## Luminaire Schedule

OSQ Series  
2@ 180

# Lighting Plan\_v1.pdf Markup Summary

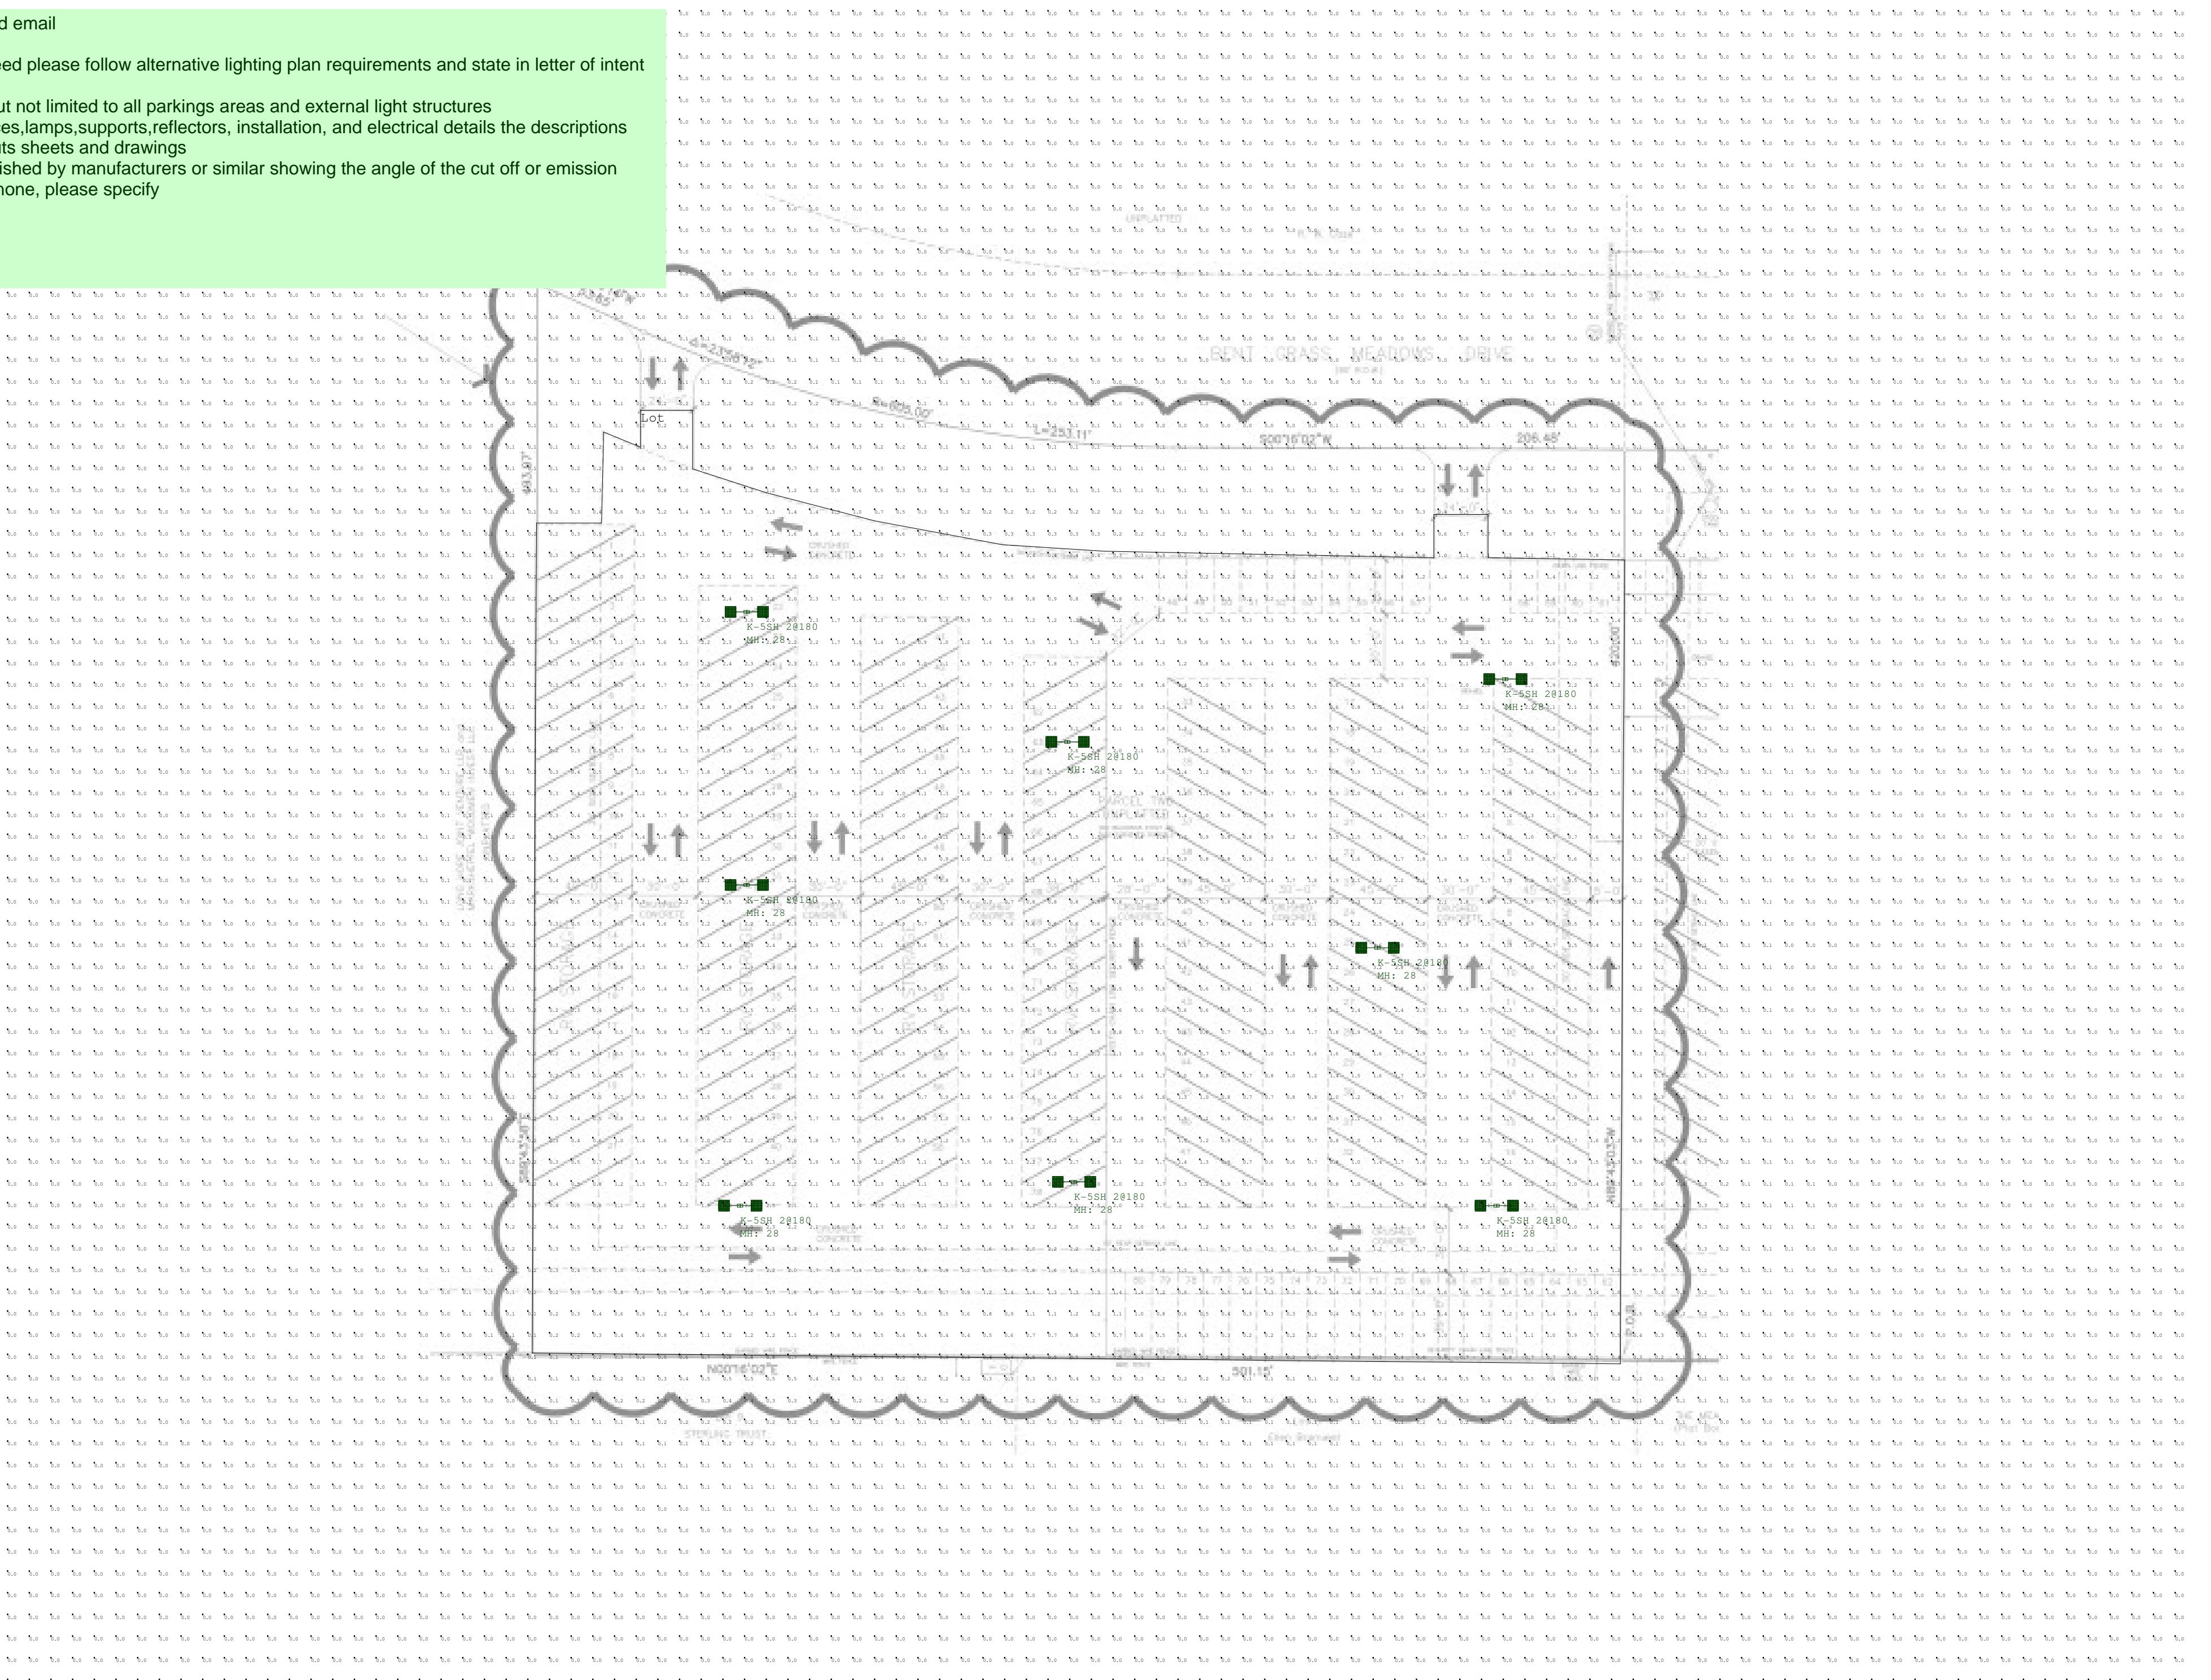
- Please depict the owner/applicants: name, phone number, and email
- Please depict a north arrow on this plan
- Cannot exceed a maximum height on 20 ft, if you plan to exceed please follow alternative lighting plan requirements and state in letter of intent

- A building footprint for all structures depicted and labeled
- The location and height of all illumination devices, including but not limited to all parkings areas and external light structures

- Please provide a detailed description for the illuminating devices,lamps,supports,reflectors, installation, and electrical details the descriptions may include but are not limited to specifications and catalog cuts sheets and drawings

- Photometric data and plan, including maps and diagrams furnished by manufacturers or similar showing the angle of the cut off or emission
- Location of all existing and proposed easements, if there are none, please specify

- Lighting:  
Section 6.2.3 of the LDC
